State of Oregon
Department of
Environmental
Quality

~~Ground Water~~Groundwater
Monitoring Plan
For
Chemical Waste Management of the
Northwest, Inc.

Arlington Facility •• ORD 089 452 353
17629 Cedar Springs Lane
Arlington, Oregon

~~June 2023~~ May 2024

Figure 7-3- Locations of WMAs and Phase 1 Selah Member Groundwater Monitoring Wells ‡ Rev. 10

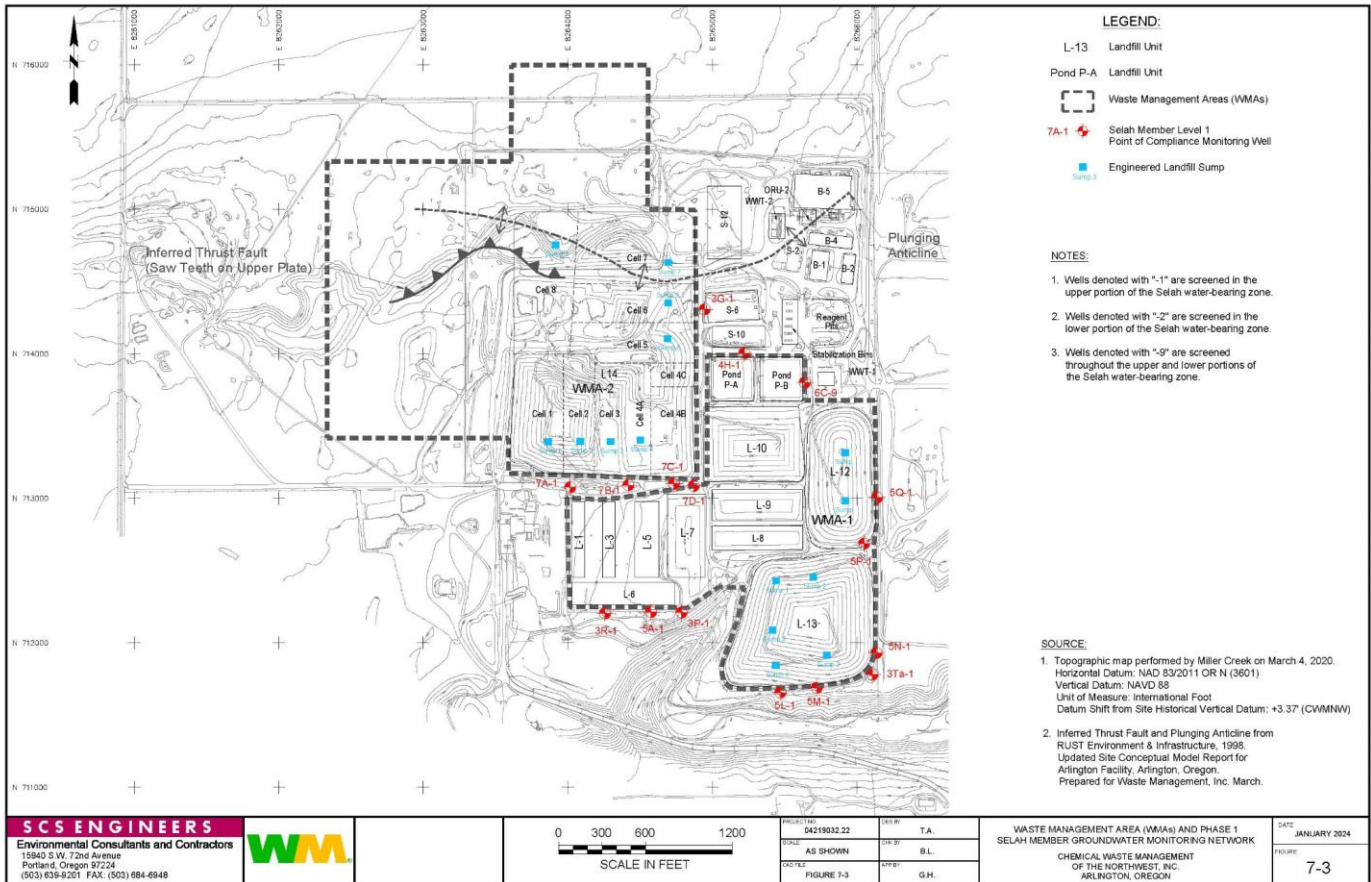
~~Piezometer~~Piezometers and select POC locations for measuring groundwater elevations are specified in Table ~~37-2~~. Figure ~~3-17-4~~ shows the locations of the wells where groundwater elevation measurements will be taken (monitoring wells and piezometers). Water level measurements may ~~also~~voluntarily be taken at other existing wells and piezometers not listed in Tables ~~7-3-4~~ and ~~3-27-4/7-5~~ (not Permit-required) to supplement the water level information that is provided by the wells listed in those tables. The list of wells provided in Table ~~37-2~~ is current as of ~~late 2014~~the date of this Plan and also reflects the outcome of the ongoing well decommissioning ~~activities~~program. This list ~~may~~will change over time, with DEQ approval, as well network maintenance activities (such as abandoning, decommissioning and, where necessary, replacing wells in the monitoring network) occurs in association with ongoing site maintenance activities and the decommissioning and replacement program outlined in the Well Abandonment Activities section below.

Figure 7-6 Map Showing Locations of WMAs and Well and Piezometer Decommissioning Program

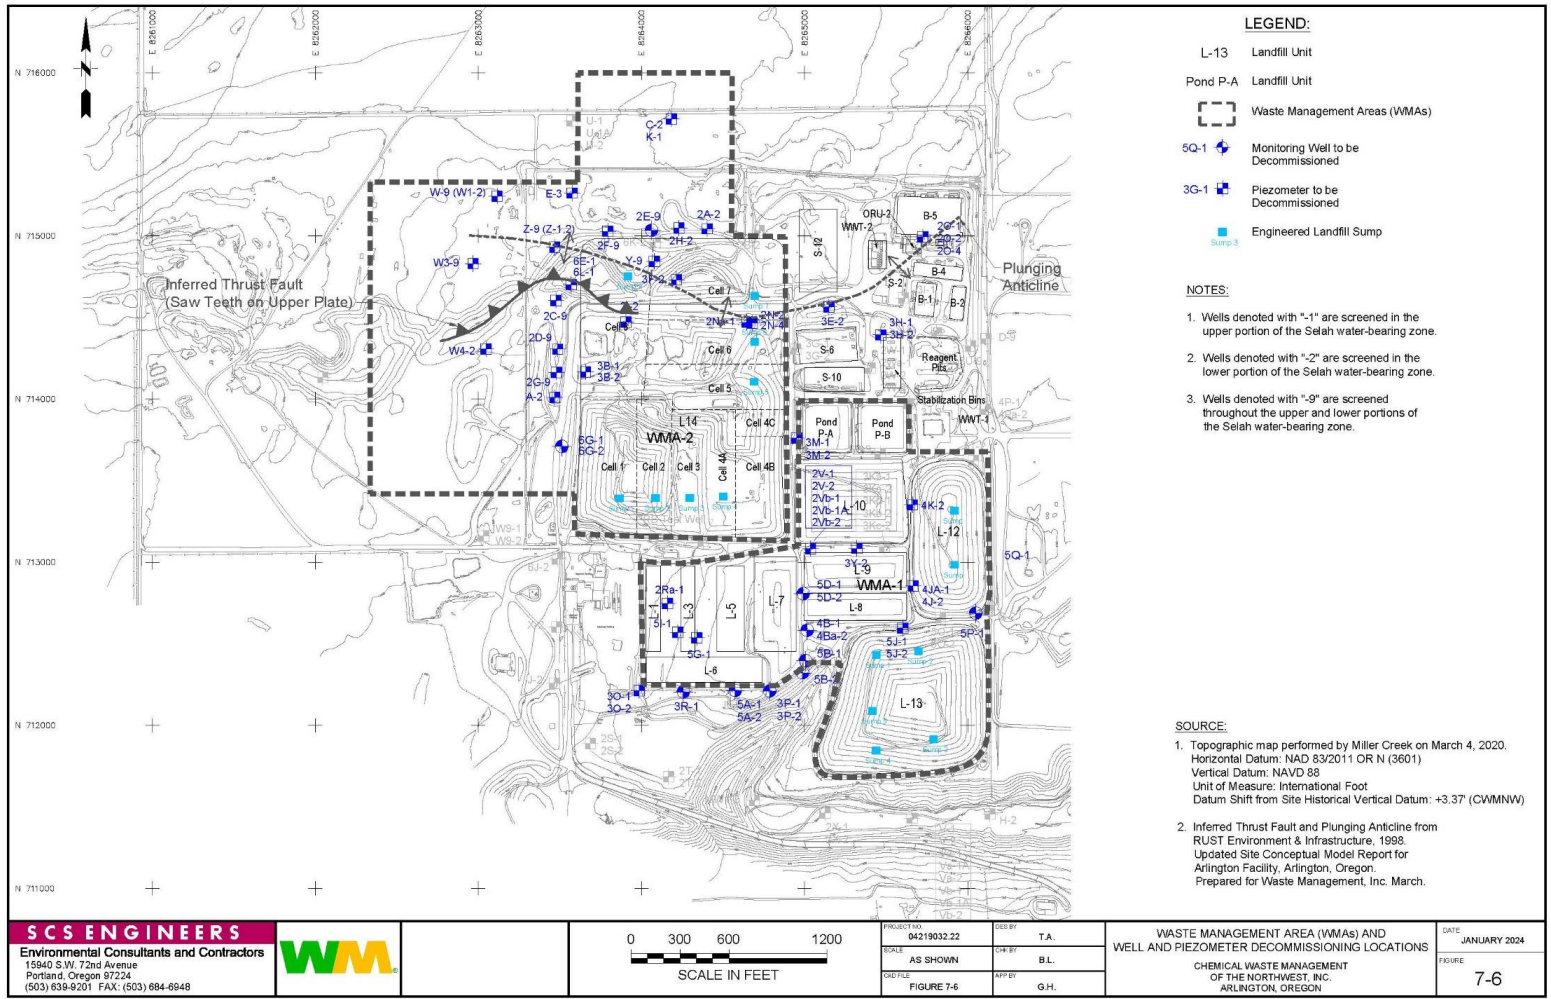
The long-term optimization program would be performed in a phased approach as the facility develops while continuing to ensure that the Phase 1 groundwater monitoring program for WMA-1 and WMA-2 is effective until the optimization program is completed. The following sections outline the phased approach and implementation of improvements to the current groundwater monitoring program presented in Table 7-3, Table 7-4, Figure 7-6 and Figure 7-4.

CWM plans to abandon and decommission a series of wells and piezometers as part of the Facility development and select wells that have identified well integrity issues (Table 7-3). Of the total locations identified for abandonment and decommissioning, some are to accommodate
